# JENSAMP-51X

## rev02 / +24/48V only

[for POS48 or FP48 PSU use]

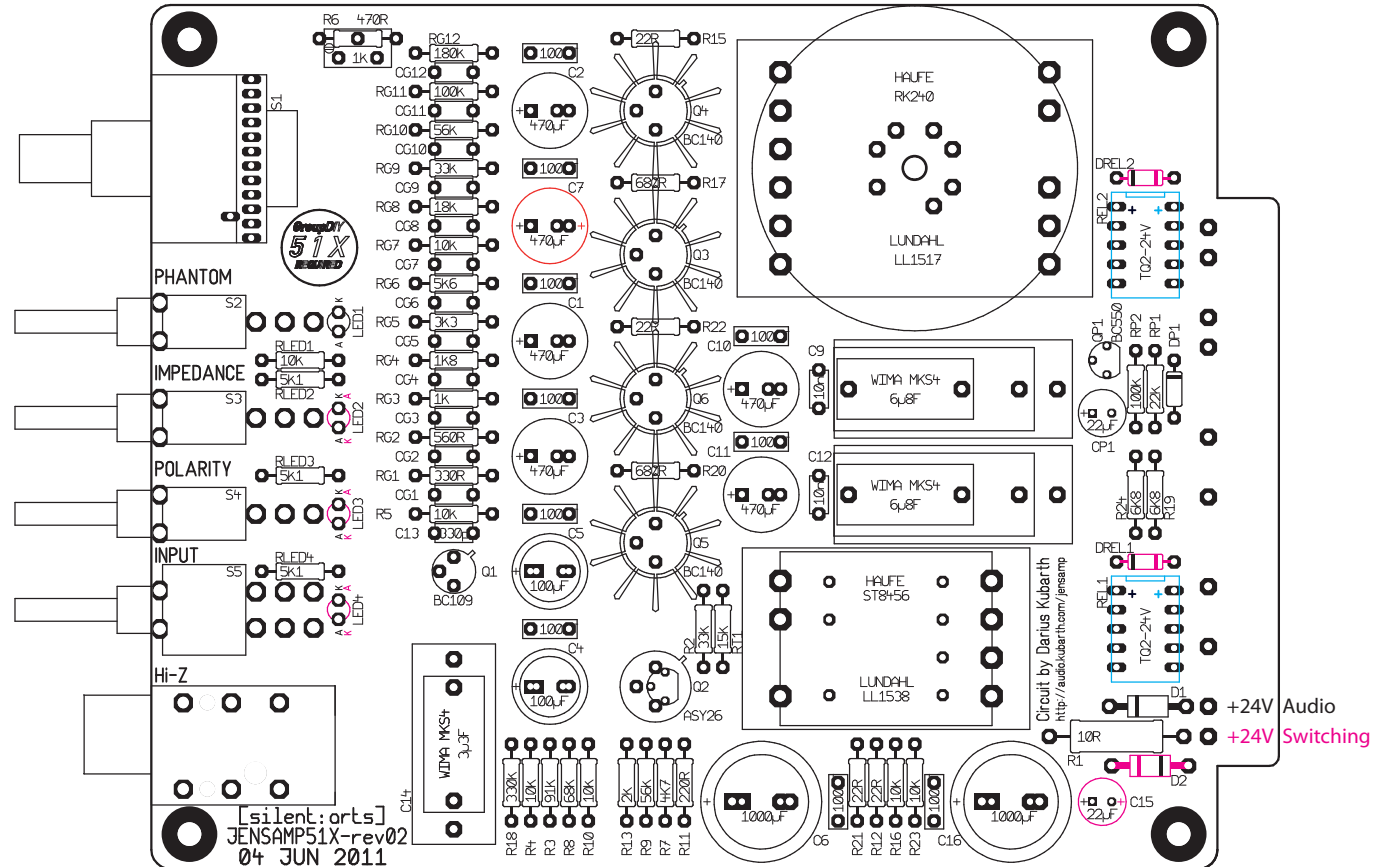
note: change polarity of C7 to reduce gain change clicks

DO NOT USE IN ANY GDIY511 RACK ANYMORE

change polarity of:  
D2 / C15 / DREL1 / DREL2  
LED2 / LED3 / LED4

change from PCB top to bottom side:  
REL1 / REL2
